Technical Bulletin / Safety Alert

Unique ID No: DES2014-TBSA-04

Subject: MDR074246DES Low Water Test Valve Change

Applicable to: ALL VLI JUG-A-0 UL/UV Machines with MDR074246DES and MDR074246DES-1

Figure 1: New 2 Way Low Water Test Valve Installation.

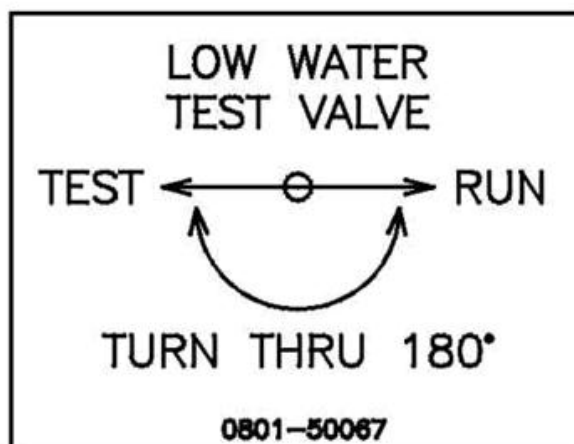
A HAZOP study and design change FMEA was completed, which supported this change. VLI subsequently installed and tested a 2 way low water test valve to a system, as depicted in Figure 1, to confirm correct fit and function. VLI now recommends the change from a 3 way ball valve to a 2 way ball valve for the low water test valve on design registered DES covered by MDR074246DES and MDR074246DES-1. The low water test valve decal, as shown in Figure 2, will need to be removed from its location on the exhaust conditioner tank and discarded.

1. Low Water Test Valve Change to 2 Way Valve

VLI recommends all equipment owners and end users of VLI JUG-A-0 UL/UV with design registered diesel engine systems covered under MDR074246DES and MDR074246DES-1 adopt the new 2 way low water test valve as described in this TBSA at the next routine service interval.

Figure 3

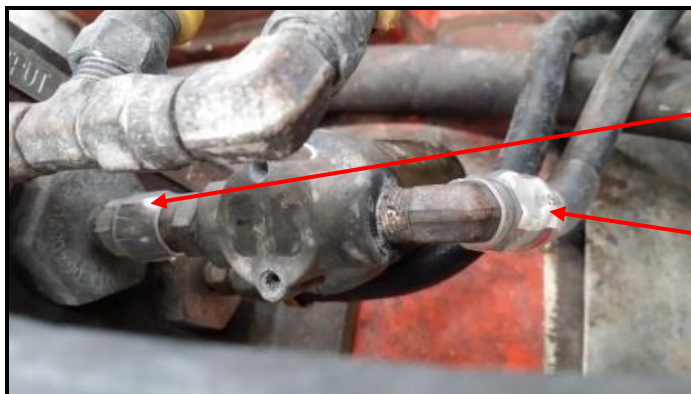
a. System with filter/drain fitted direct:

Date tag & heat-shrink applied to the air supply in –
NOTE: the heat-shrink must cover the end of the swivel nut on the hose tail.

Filter/drain fitted directly to shutdown system enclosure air supply in.

Figure 7

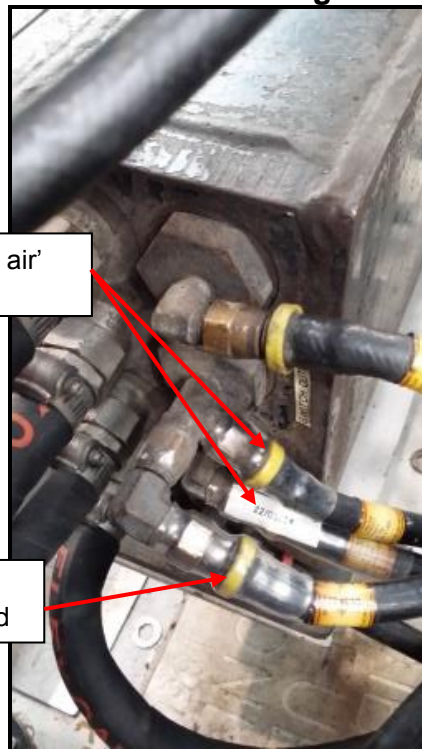
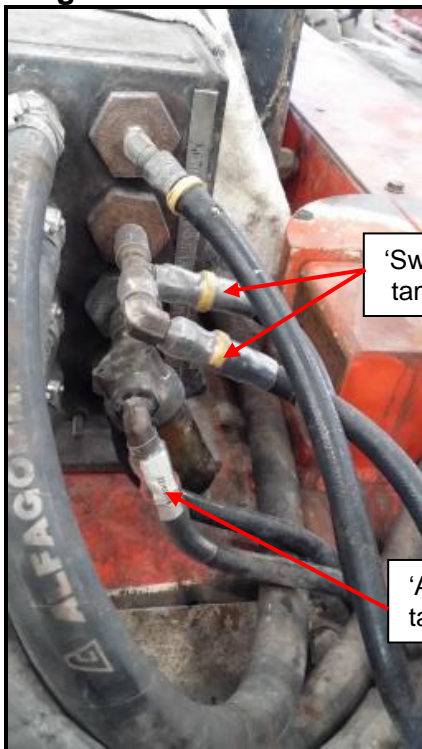
b. System with filter/drain mounted on engine rail.

Cut heat-shrink to 75mm long & apply so that it fully encapsulates the swivel nut on the hose tail.
